Addendum: **2**
 Date: **03/21/2025**
 Project: **SACS 2025 Chiller Replacements**
 Comm #: **24688**

Project Name: SACS 2025 Chiller Replacements

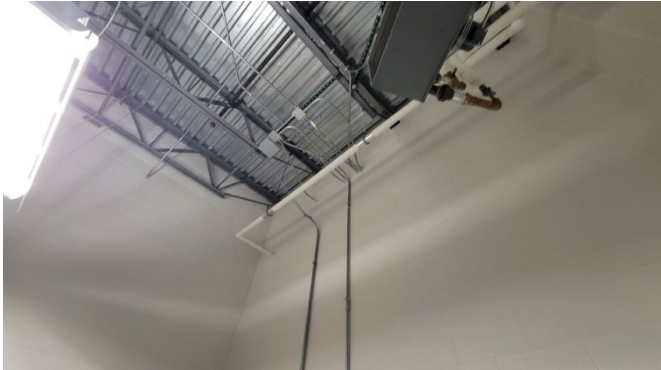
- A. See attached for pre-bid meeting sign-in sheet and meeting minutes.
- B. Question: *“Woodside MS Chiller, remark #13 on chiller schedule. Is the Unitary “SM” or Unitary “SM-SB” requested?”*
Response: Intent is for Unitary “SM” to be bid, as shown below.

SHEET:
WM-E101

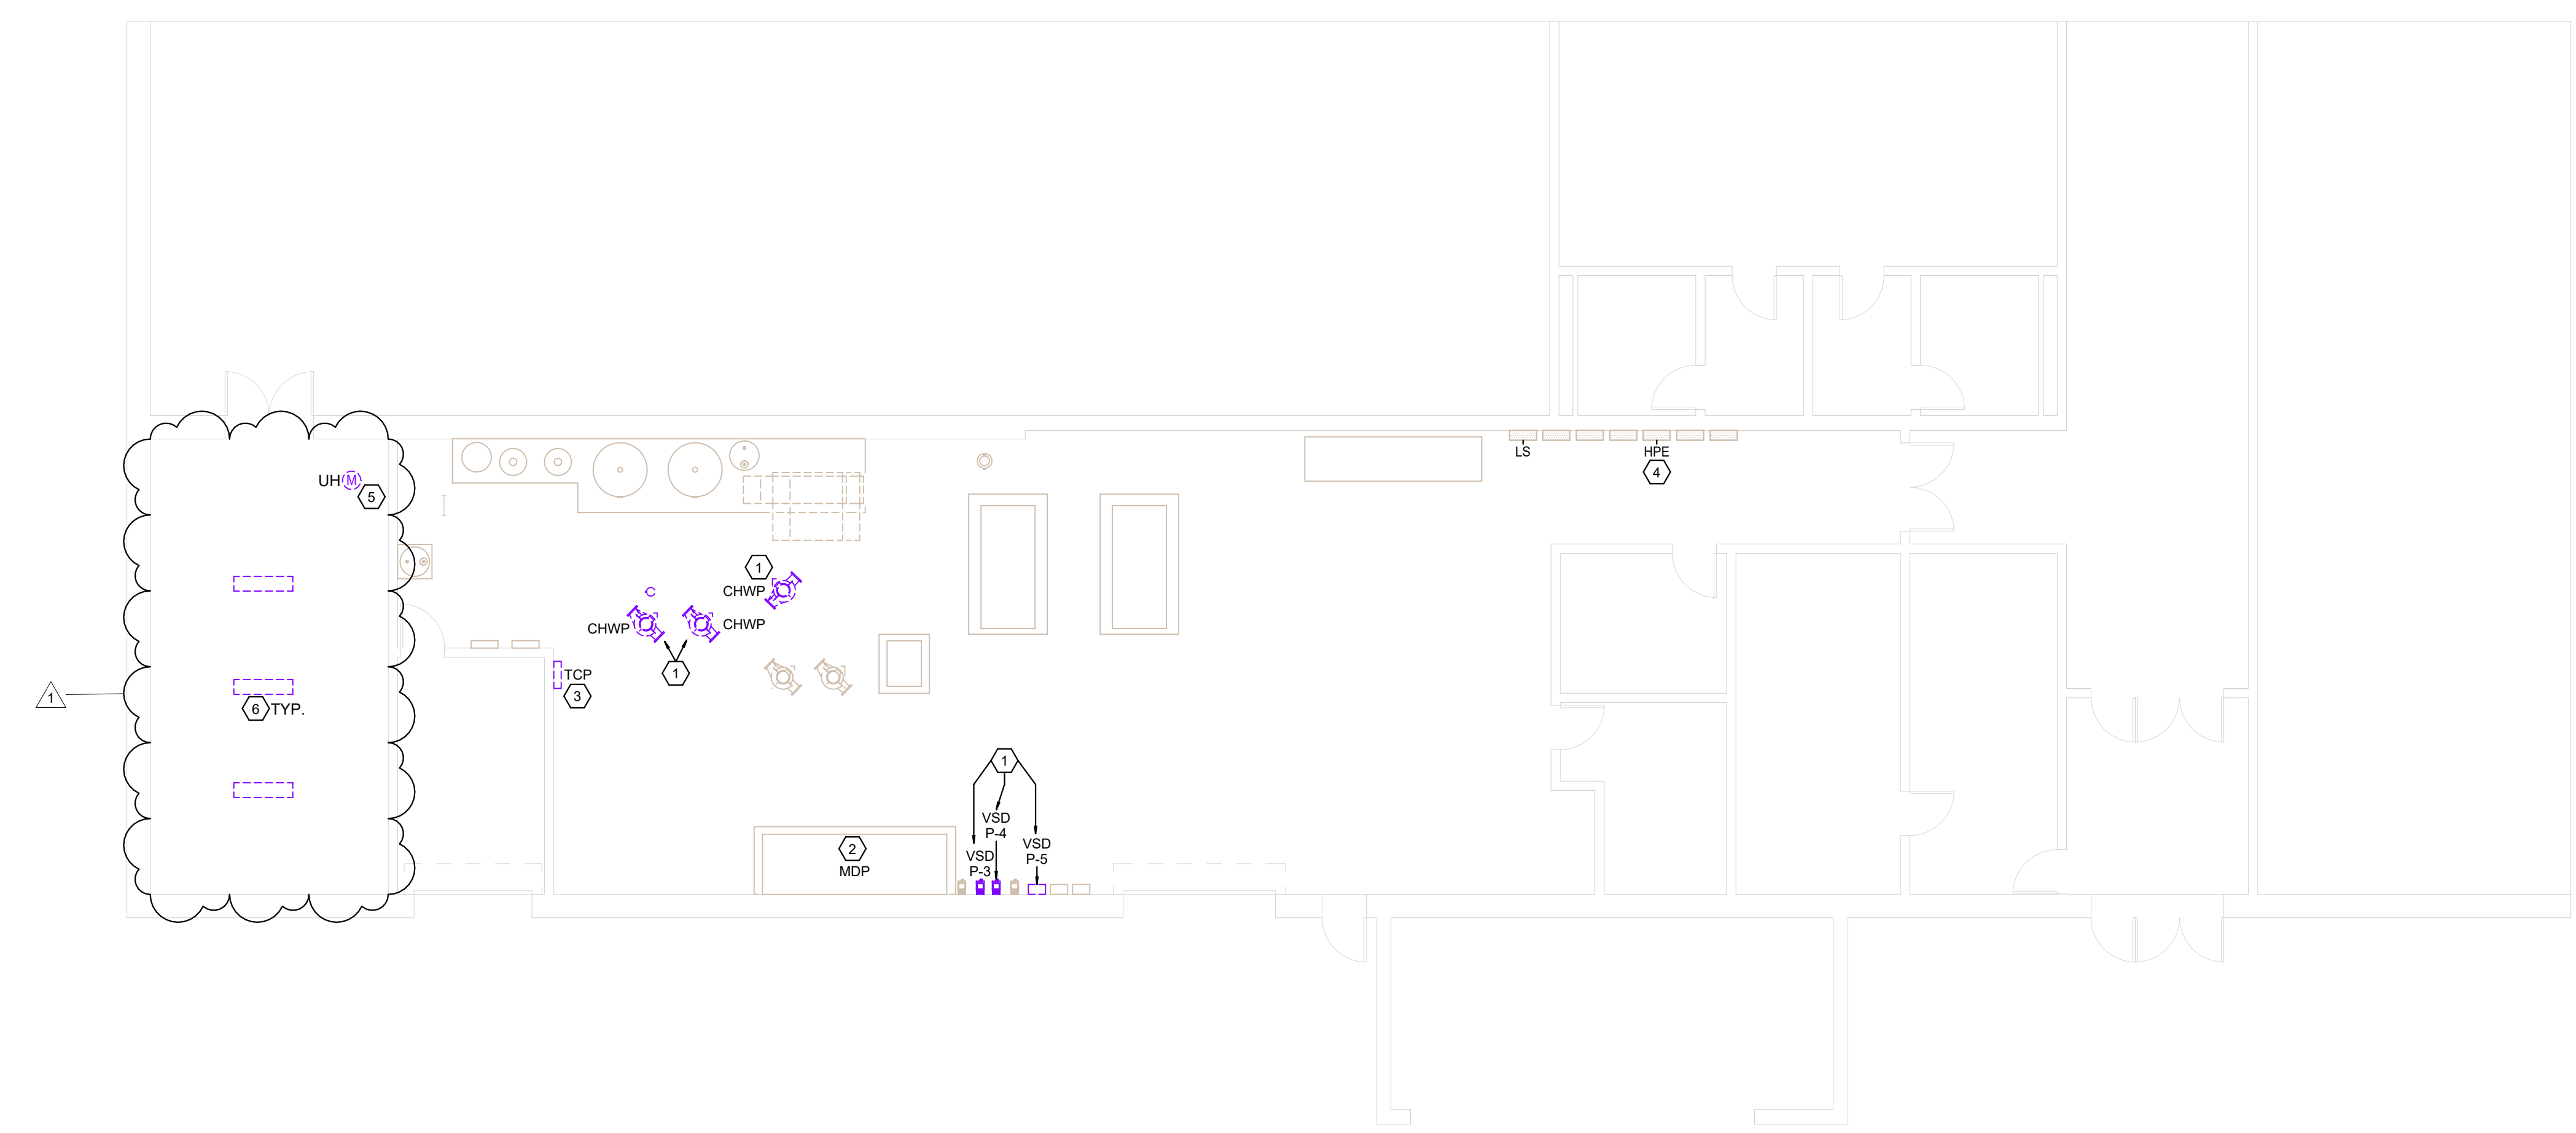
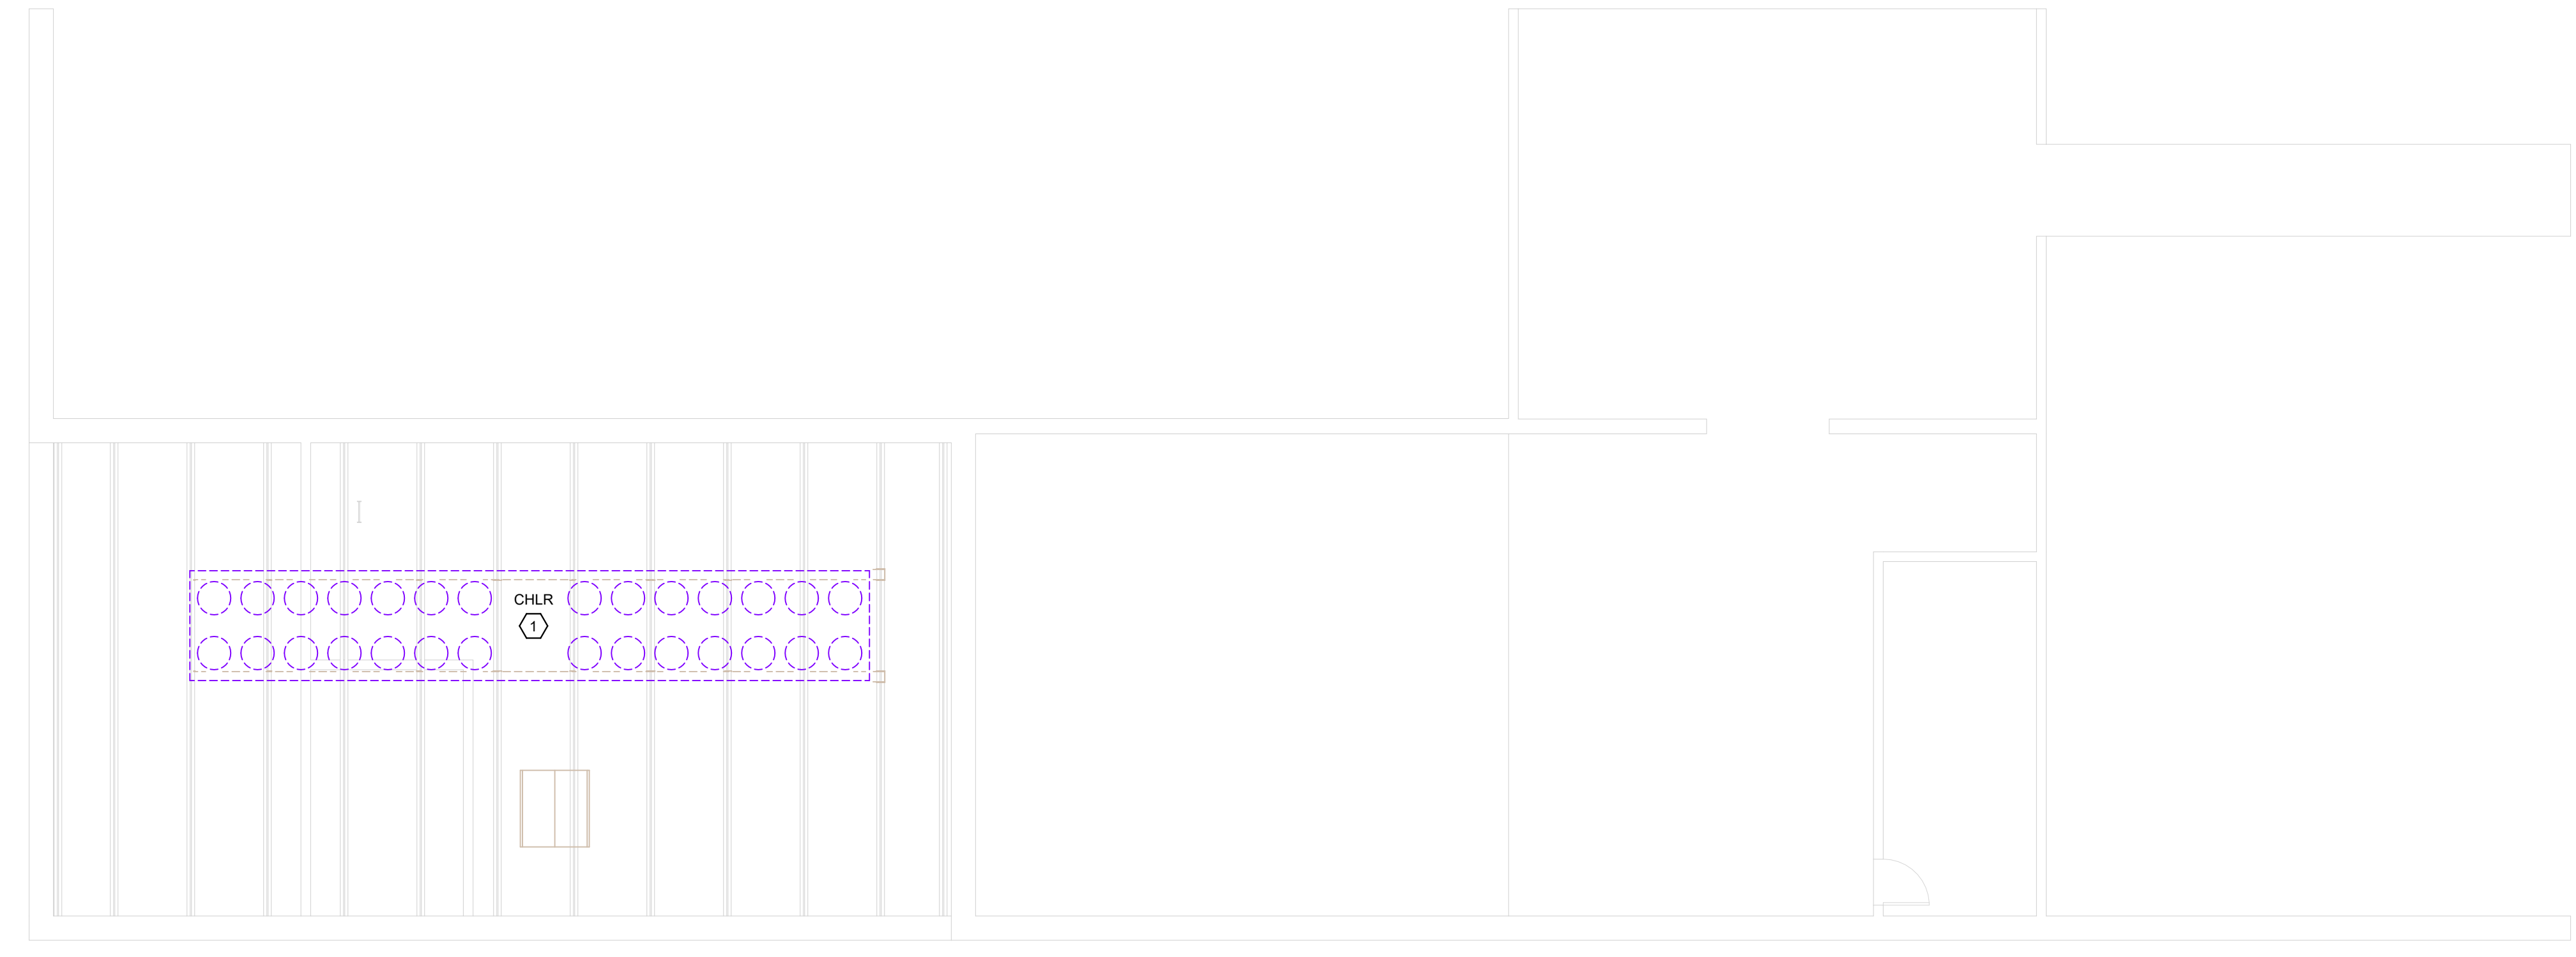
Item #2: Drawing Sheet WM-E101, "Electrical Demolition Plan"

- A. Revised drawing to include demolition of electrical items on beam that is being replaced. Refer to supplemental information drawing sheet WM-E101, labeled addendum #2.

5. DISCONNECT EXISTING MECHANICAL EQUIPMENT AS REQUIRED FOR NEW BEAM. EXISTING WIRING TO REMAIN. PREPARE EXISTING WIRING AND CONDUIT TO BE EXTENDED AND REROUTED AS REQUIRED FOR RECONNECTION. COORDINATE WITH PROPER TRADES PRIOR TO DISCONNECTION.

6. DISCONNECT AND SALVAGE EXISTING LIGHT FIXTURES AS REQUIRED FOR NEW BEAM. EXISTING WIRING TO REMAIN. PREPARE EXISTING WIRING AND CONDUIT TO BE EXTENDED AND REROUTED AS REQUIRED FOR REINSTALL OF EXISTING FIXTURES. COORDINATE WITH PROPER TRADES PRIOR TO DISCONNECTION.

SHEET:
WM-E201

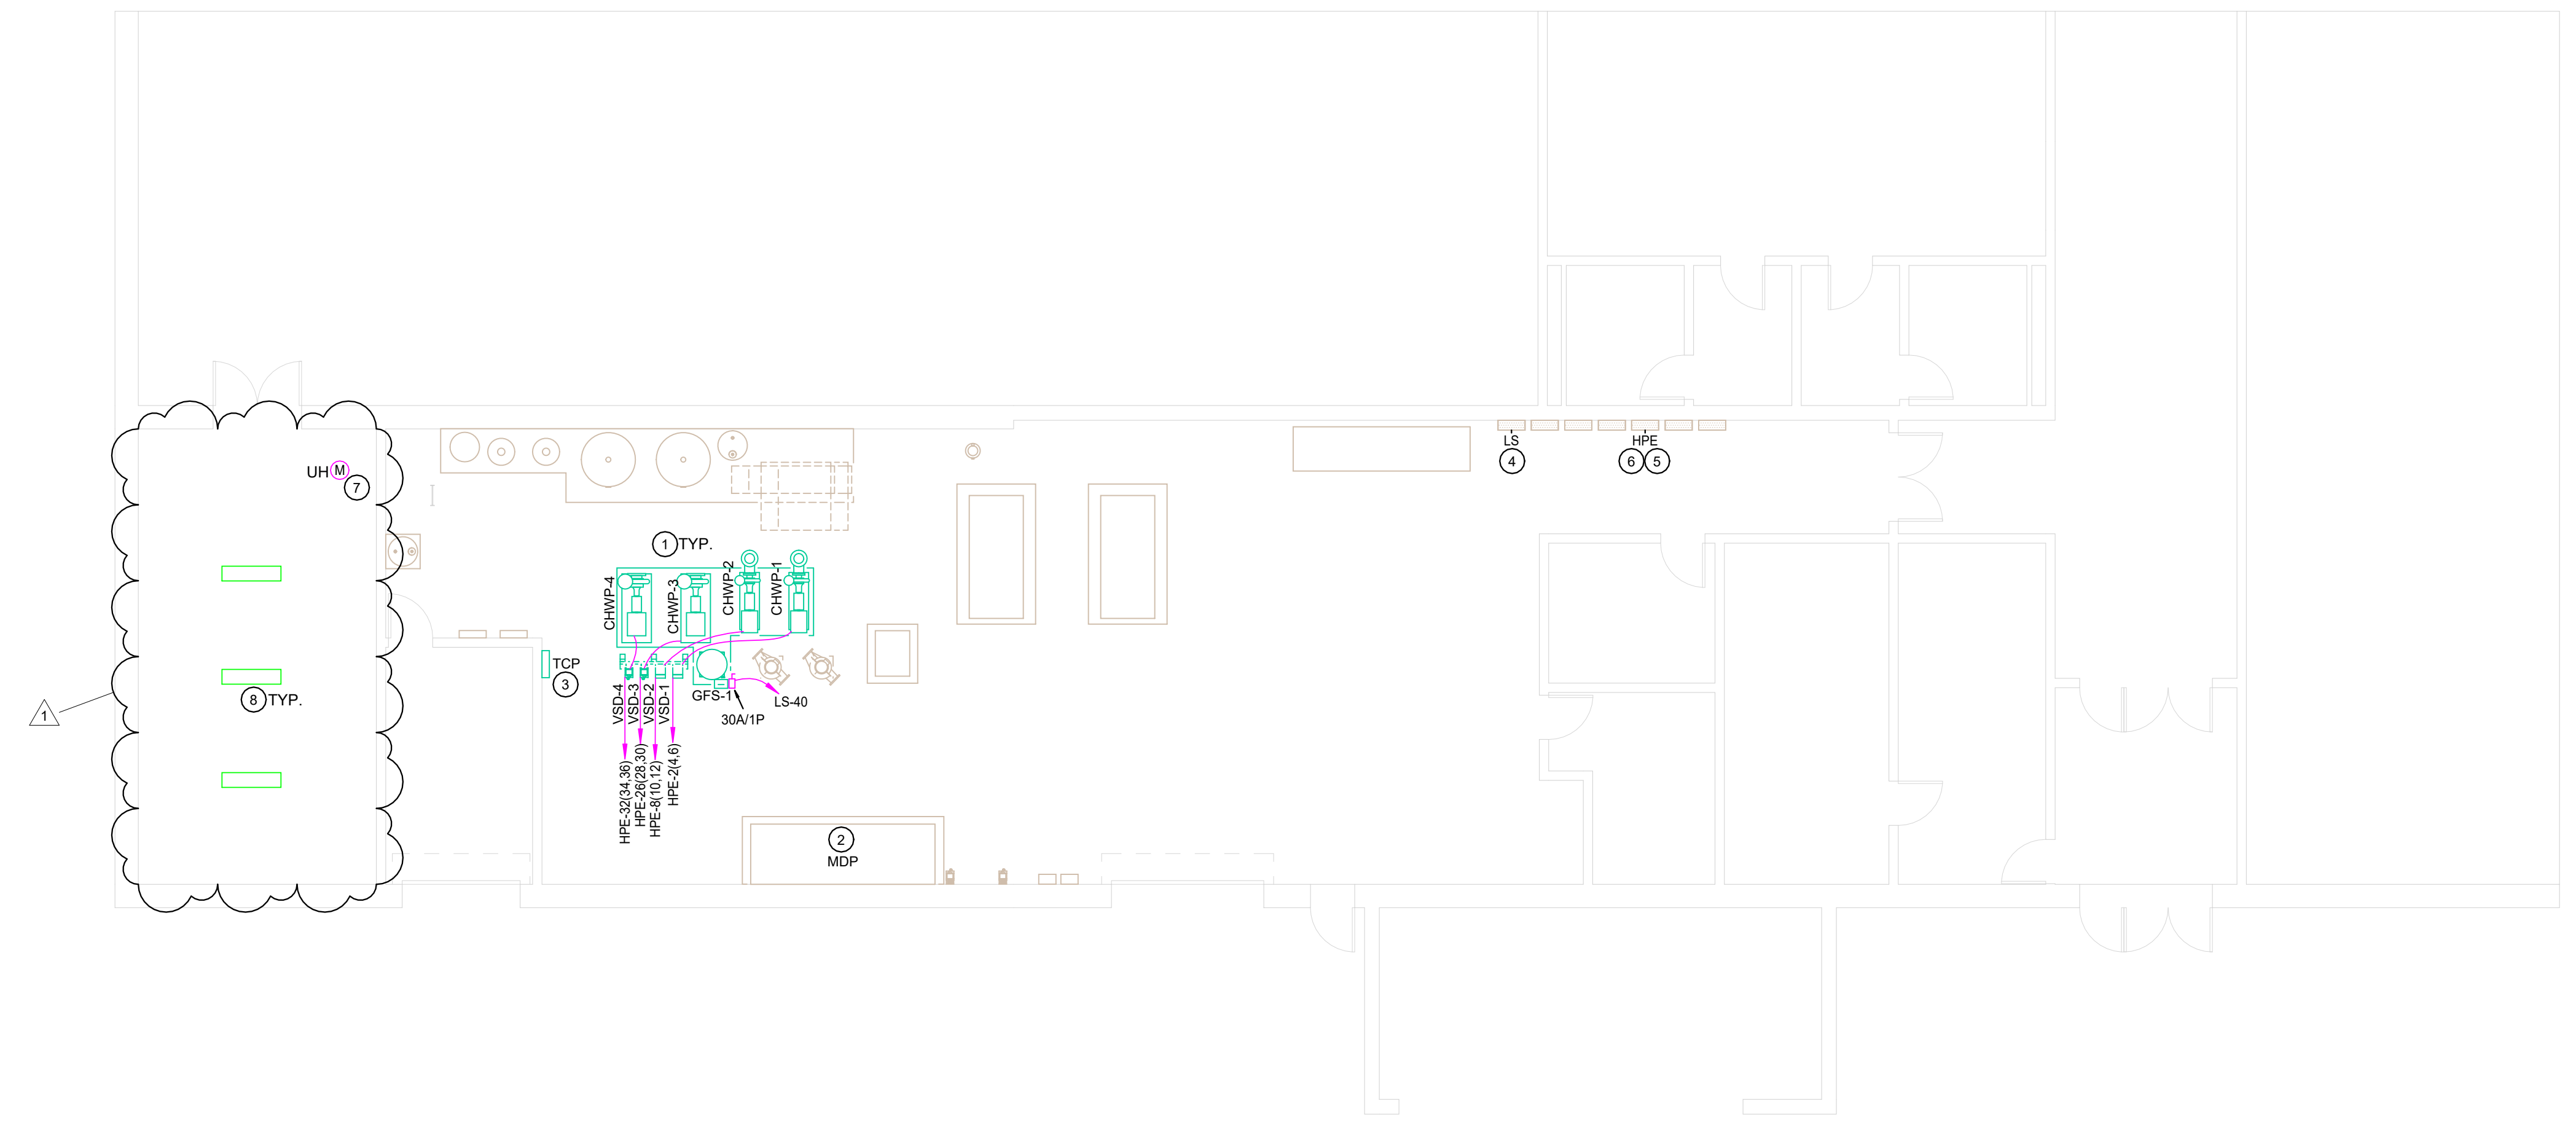
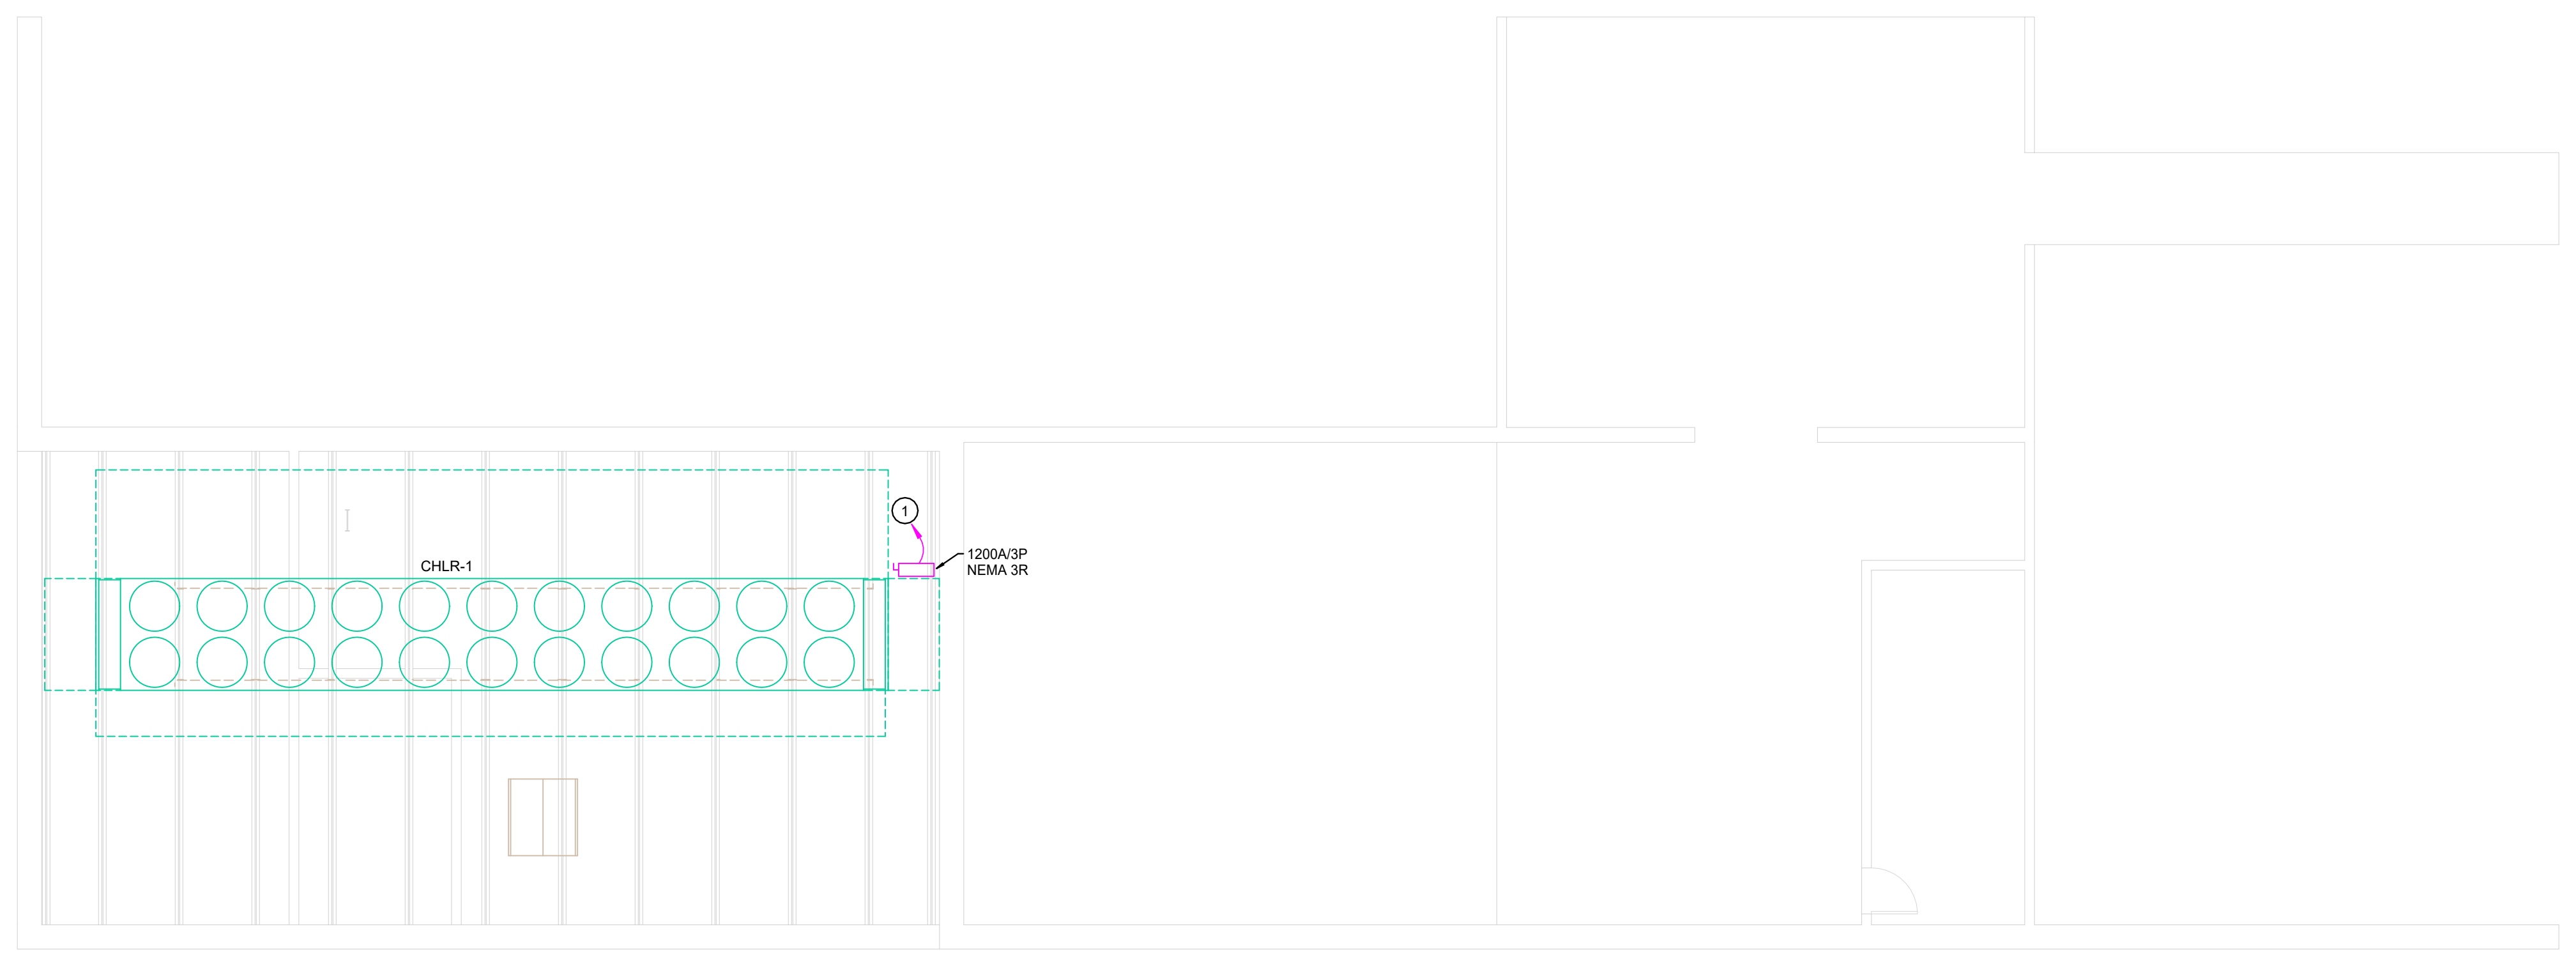
Item #3: Drawing Sheet WM-E201, "Electrical Plan"

- A. Revised drawing to include reinstallation of electrical items on beam that is being replaced. Refer to supplemental information drawing sheet WM-E101, labeled addendum #2.

- RECONNECT TO EXISTING MECHANICAL EQUIPMENT. INTERCEPT, EXTEND AND REROUTE EXISTING WIRING AND CONDUIT AS REQUIRED. COORDINATE WITH PROPER TRADES PRIOR TO CONNECTION.

- REINSTALL EXISTING LIGHT FIXTURE IN EXISTING LOCATION. INTERCEPT, EXTEND AND REROUTE EXISTING WIRING AND CONDUIT AS REQUIRED. PROVIDE ALL NECESSARY MATERIALS FOR COMPLETE INSTALL. COORDINATE WITH PROPER TRADES PRIOR TO REINSTALL.
